WATERLOO METRO QUARTER DEVELOPMENT

Site Plan

RTS Changes

Sheet title
General Arrangement Plan
Roof Plan

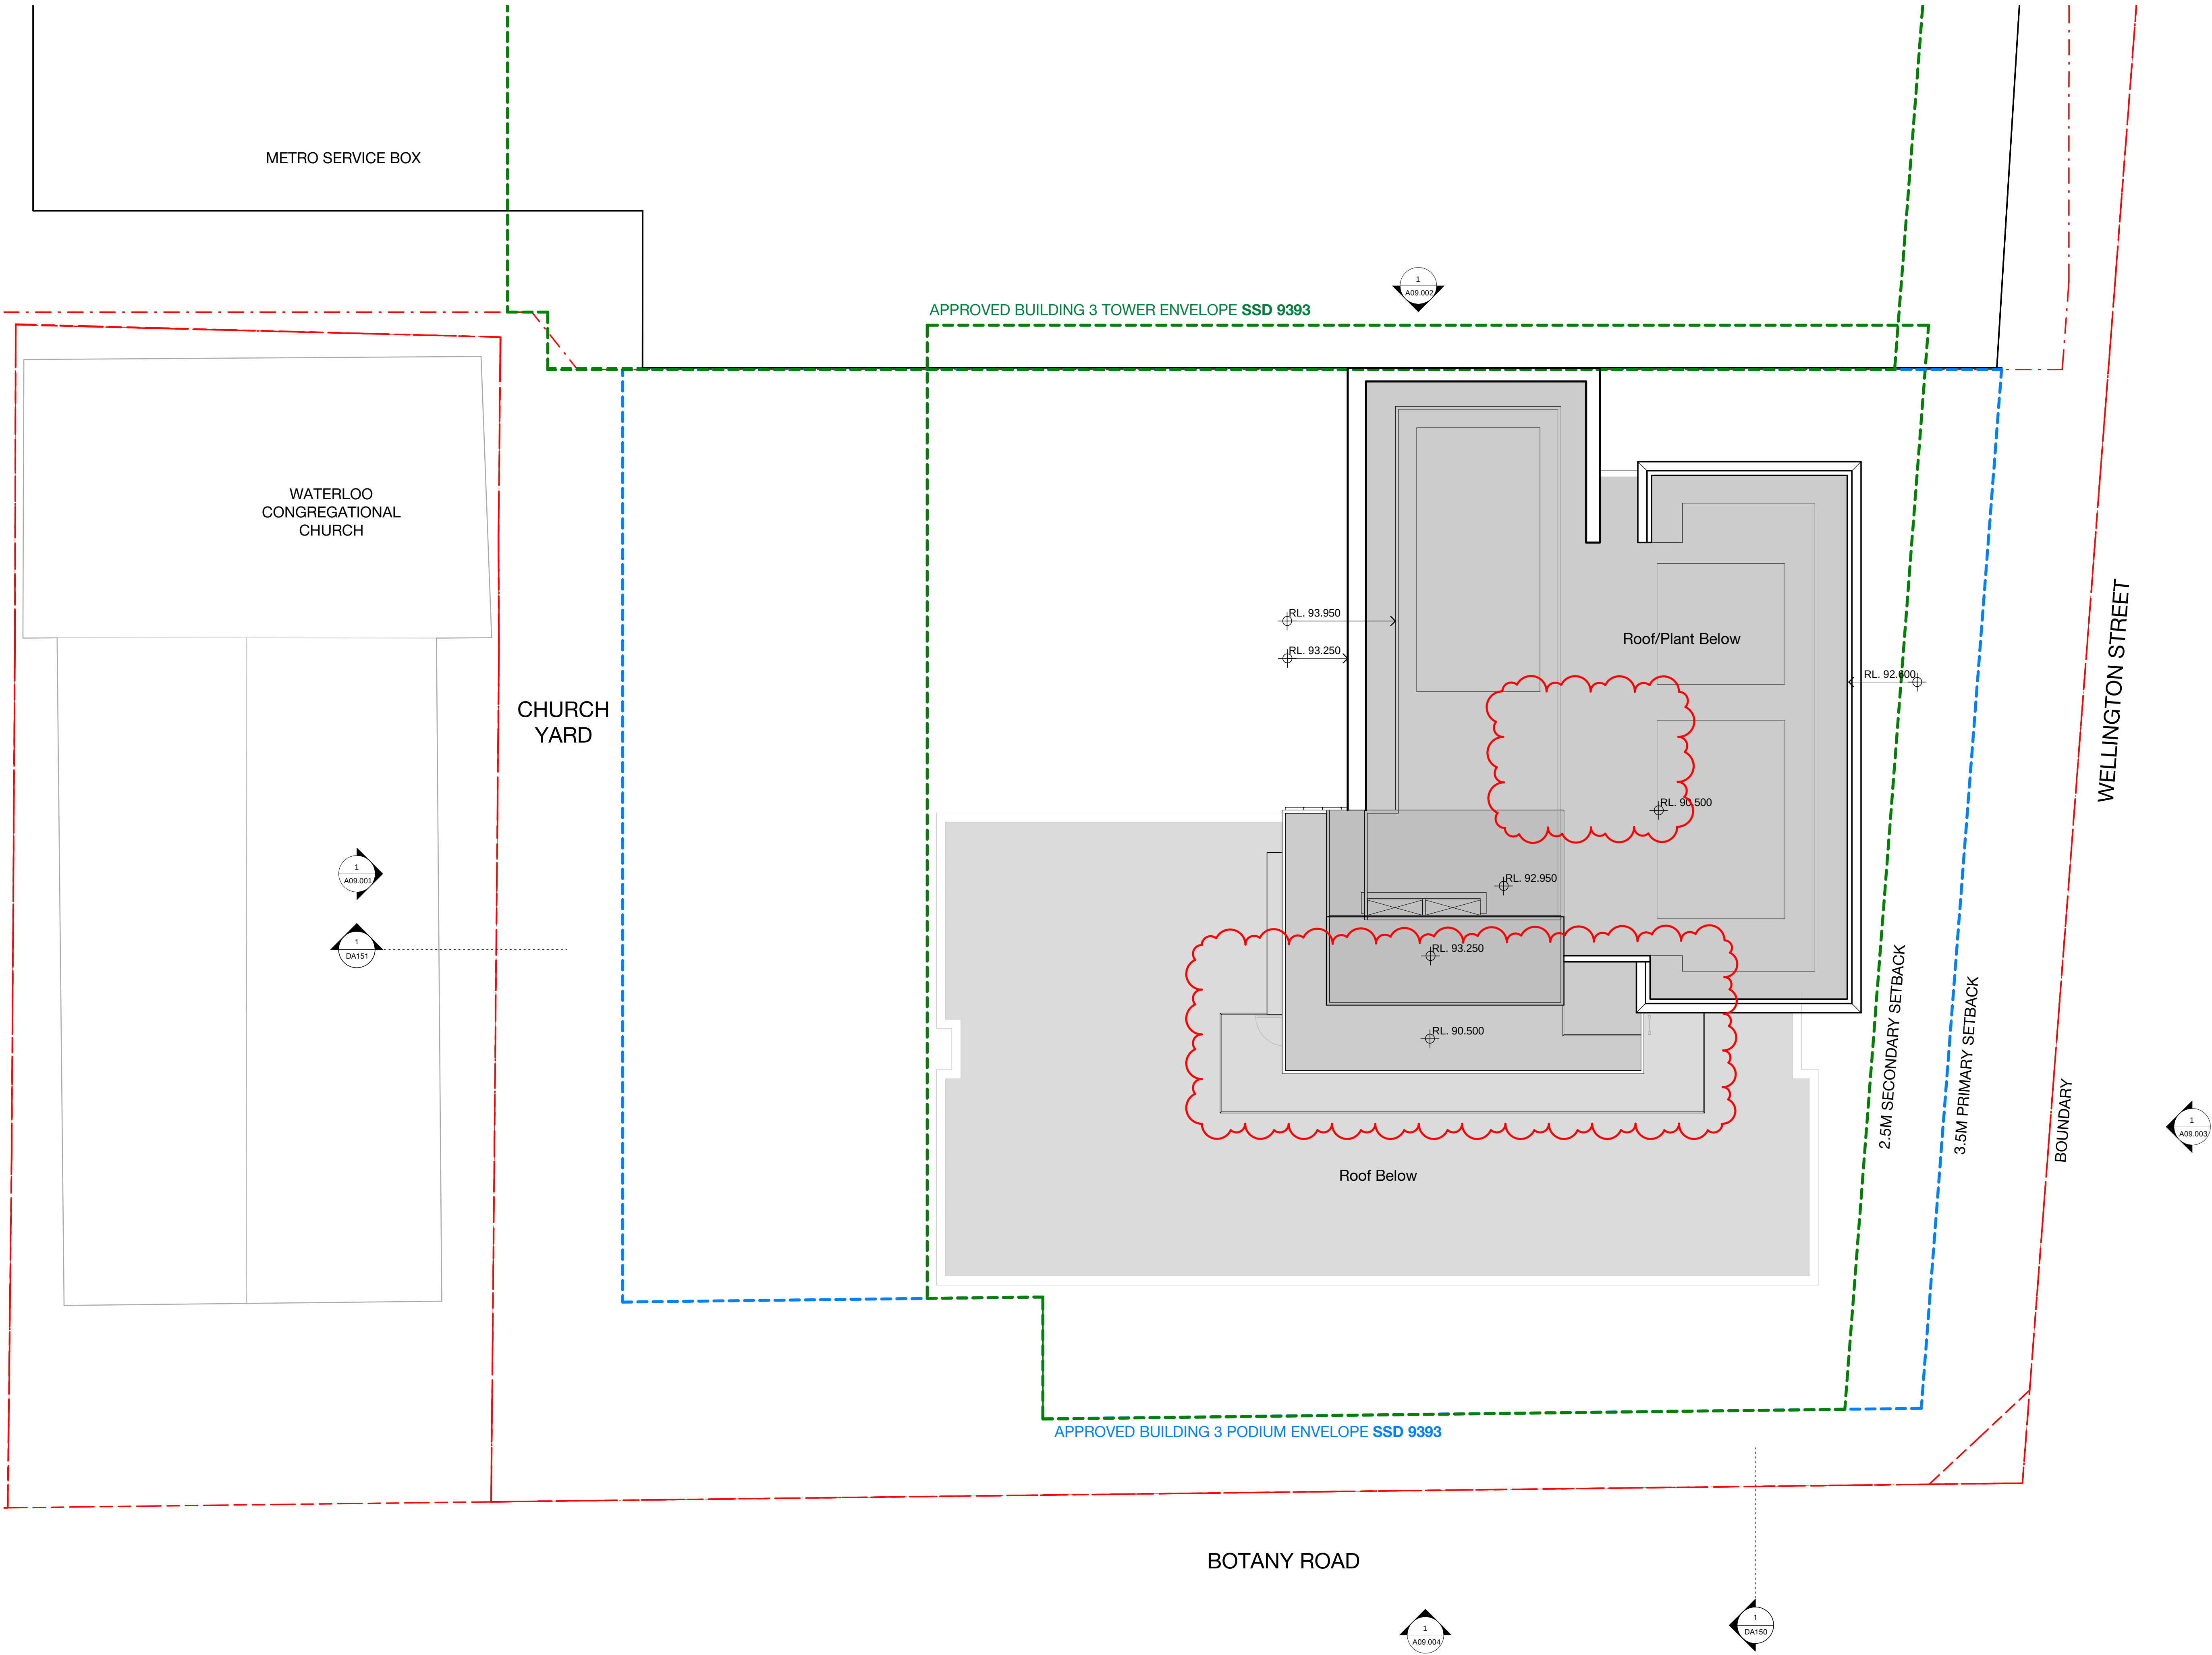
- Comms Room Removed from Roof
- Addition of Guard Rail

Elevation - North

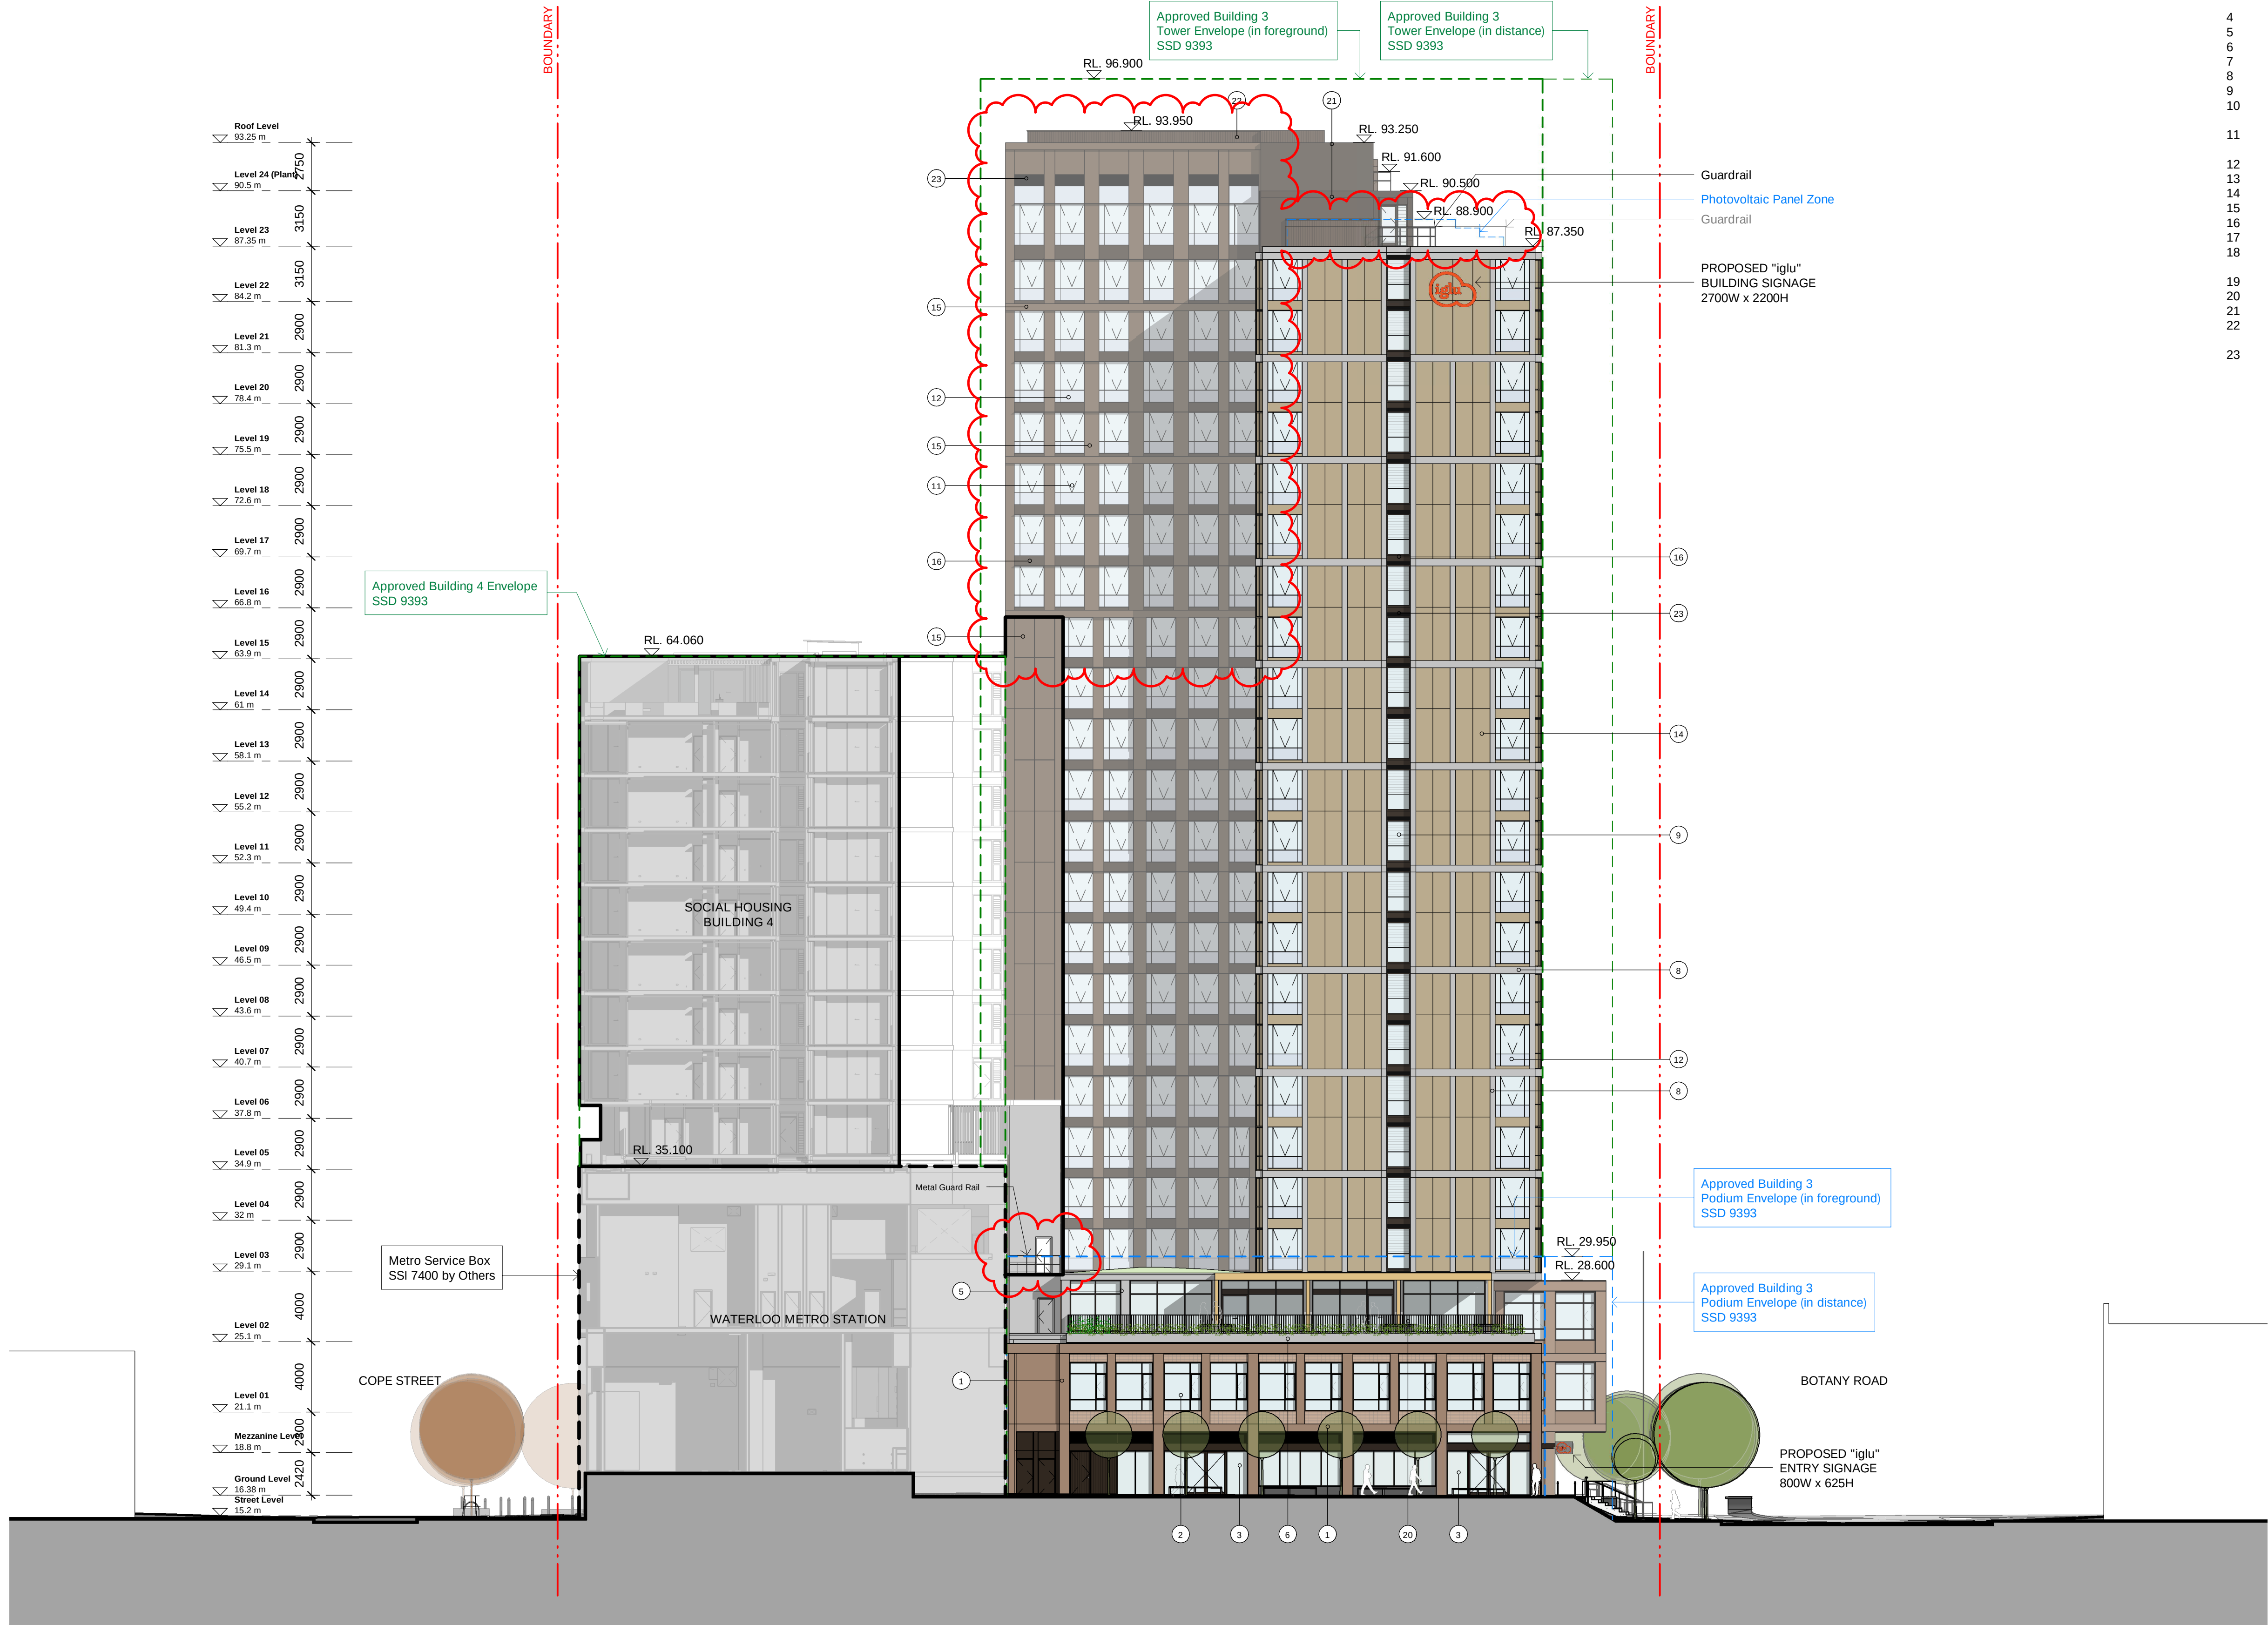
- Change to Horizontal Sun Shades on Northern Facade Level 16 to 22
- Addition of Guardrail
- Guardrail for Pohotovoltic Panel Zone Reinstated

Elevation - West

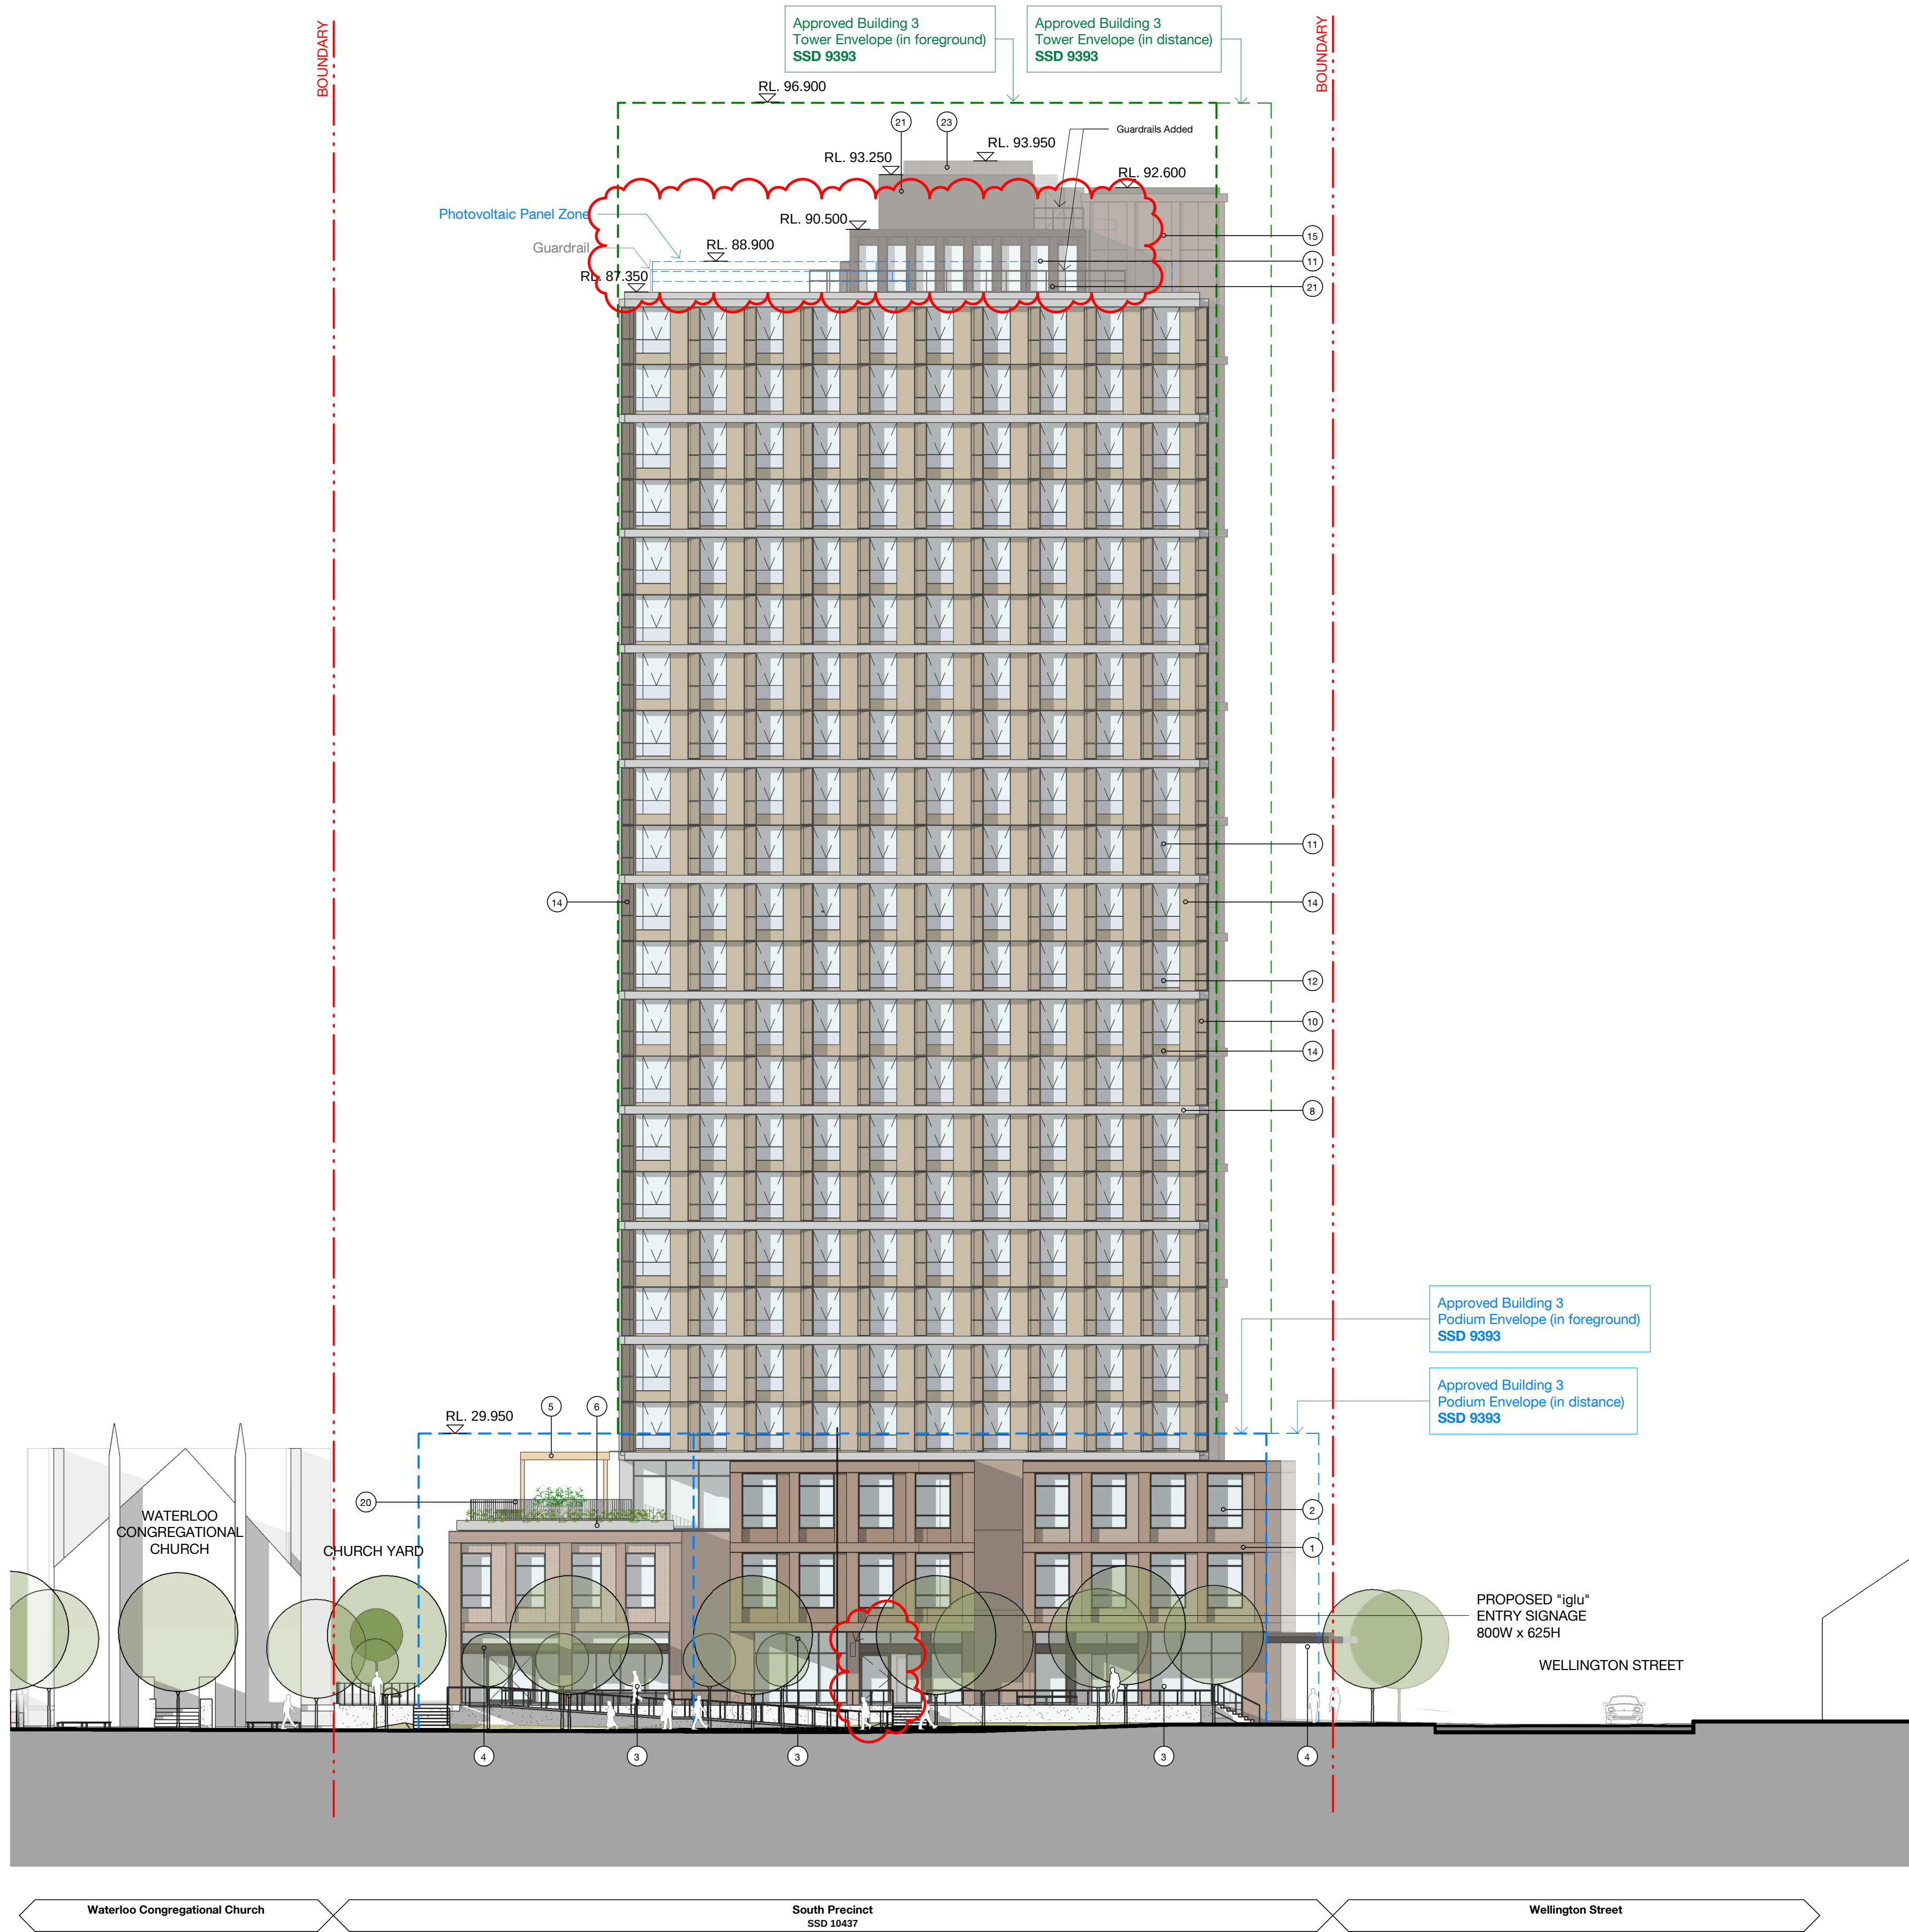
- Addition of Guardrail
- Guardrail for Photovoltaic Panel Zone Reinstated
- Addition of Swing Door in Student Accommodation Lobby
